SUBJECT: NuScale Power, LLC Supplemental Response to NRC Request for Additional Information No. 282 (eRAI No. 9196) on the NuScale Design Certification Application

NuScale Supplemental Response to NRC Request for Additional Information eRAI No. 9196

eRAI No.: 9196

NRC Question No.: 19-36

Figure 9.3.4-1: Chemical and Volume Control System Diagram

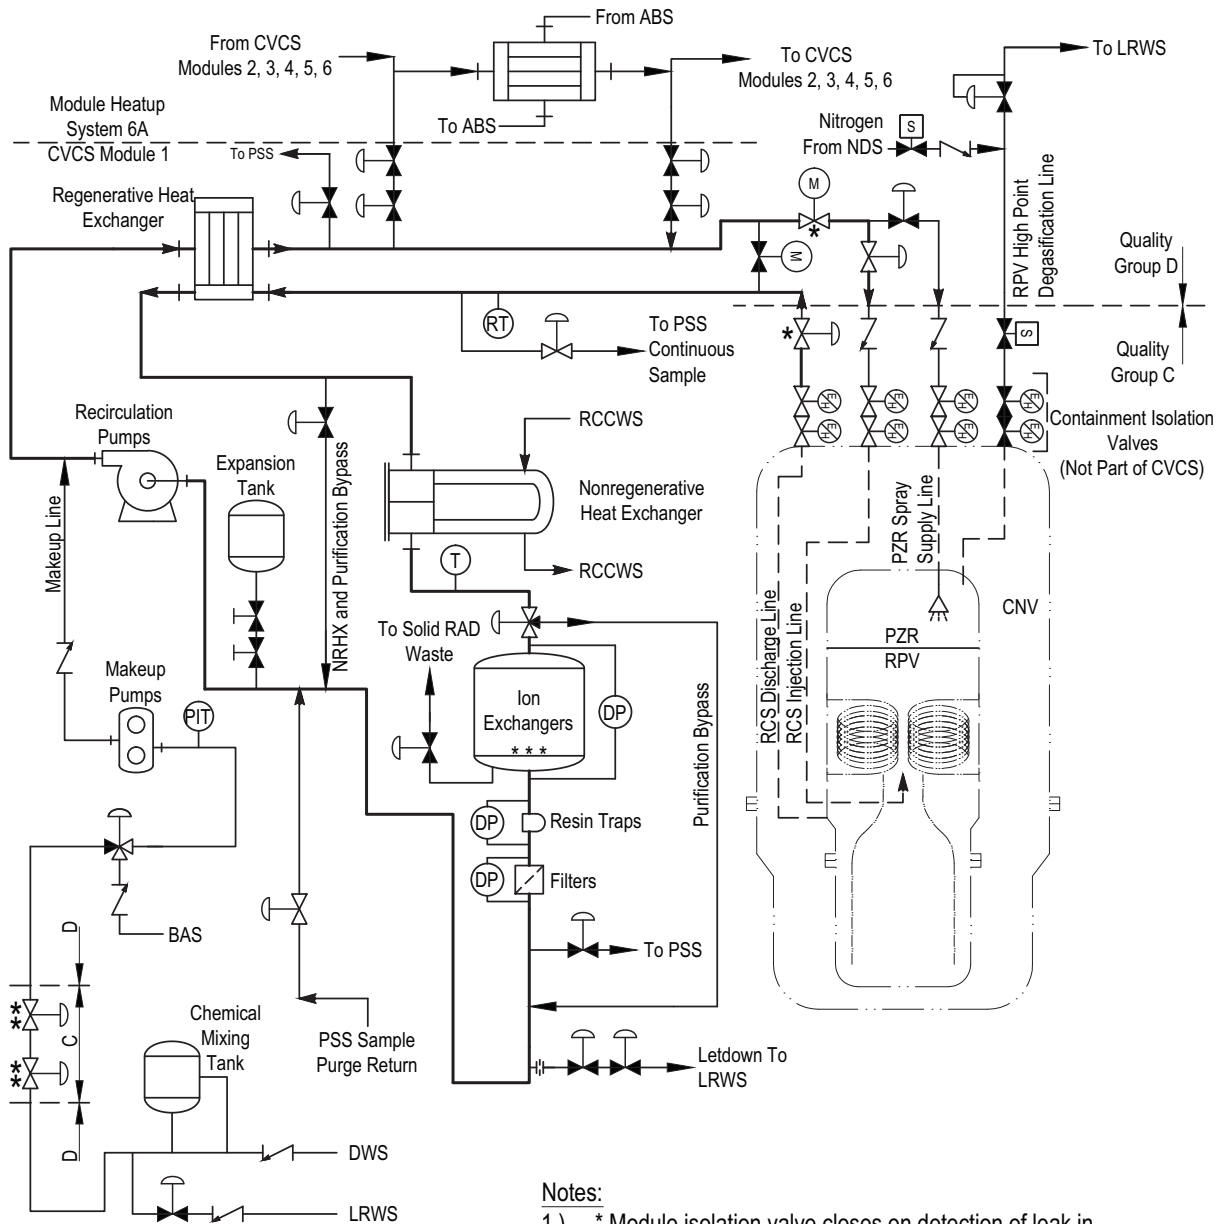
Final Safety Analysis Report (FSAR) Section 19.2.2.5 states that the chemical and volume control system (CVCS) is the only system connected to the RCS that has piping outside containment, the CVCS is designed to RCS pressure, and the CVCS has pressure isolation

The information in FSAR Section 9.3.4 indicates that CVCS subsystems may not meet the guidance in SECY-93-087. FSAR Table 9.3.4-1 lists 150 psig as the design pressure for the CVCS Chemical Mixing Tank and the CVCS Expansion Tank.

The information in FSAR Section 9.3.4 indicates that CVCS connecting systems (i.e., systems that are connected to the RCS via the CVCS) may not meet the guidance in SECY-93-087. CVCS connecting systems (e.g., liquid radioactive waste system, demineralized water system, process sampling system, boron addition system) are shown in Figure 9.3.4-1. FSAR Table 9.3.4-2 lists 125 psig and atmospheric pressure as the design pressure for two of the components in the boron addition system which is a CVCS connecting system.

FSAR Figure 9.3.4-1 has been revised to include the pressure indicating transmitters on the suction of each of the CVCS makeup pumps. The figure has also been revised to show the check valve that is provided between the makeup pumps' discharge and the injection tee into the recirculation loop.

FSAR Section 9.3.4.3 and Figure 9.3.4-1 have been revised as described in the response
